SUNSET LAKE DAM
COLE COUNTY, MISSOURI
MISSOURI INVENTORY NO. 30341

PHASE I INSPECTION REPORT
NATIONAL DAM SAFETY PROGRAM

PREPARED BY: ST. LOUIS DISTRICT CORPS OF ENGINEERS
FOR: GOVERNOR OF MISSOURI

JULY 1978

PHOTO 3: Spillway Exit Channel

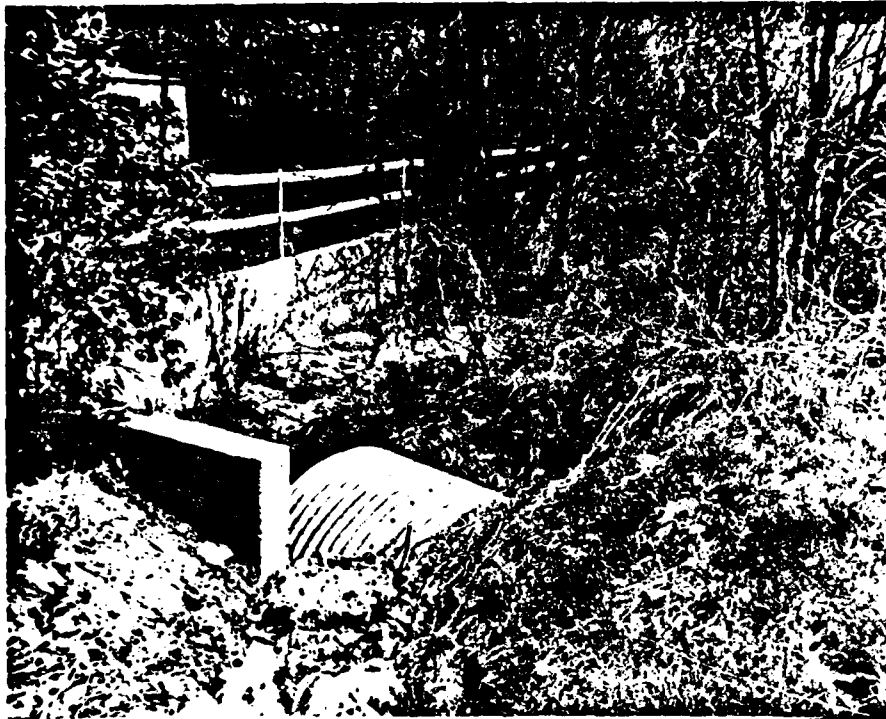
3) Exit channel at CMP outlet has sediment deposition and trees and vegetation growing in channel. See Photo 3.

(4) Remove sediment and vegetation in the downstream exit channel.

PHOTO 6: Homes Downstream of Dam

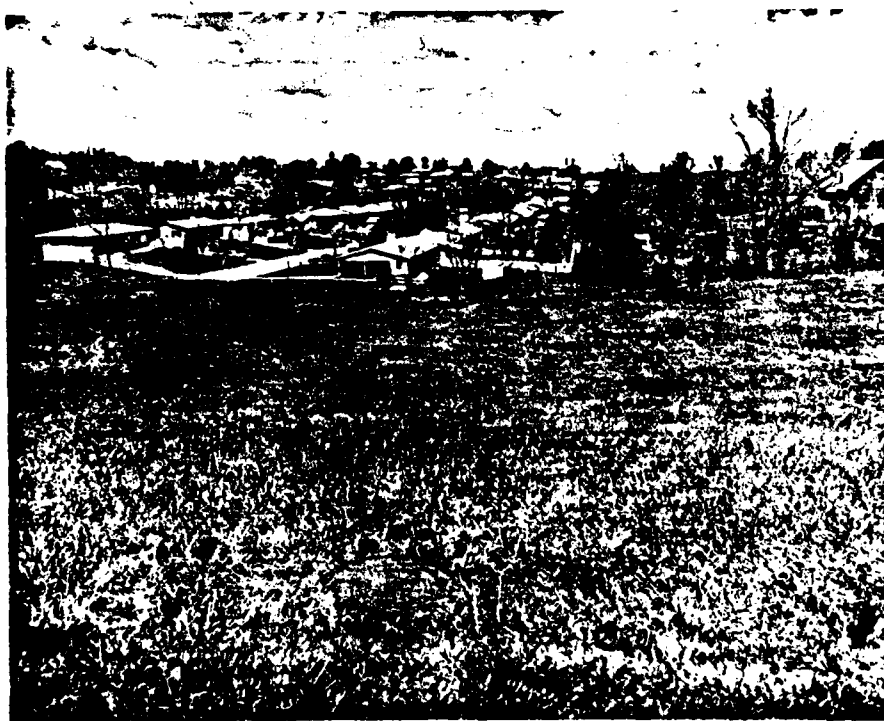
Overtopping could cause a sudden failure of the dam, which would result in damages to homes located immediately below the dam (see Photo 6) and probable loss of life. No effective warning system could be implemented which would alert the residents to the danger in sufficient time to allow evacuation or remedial actions.
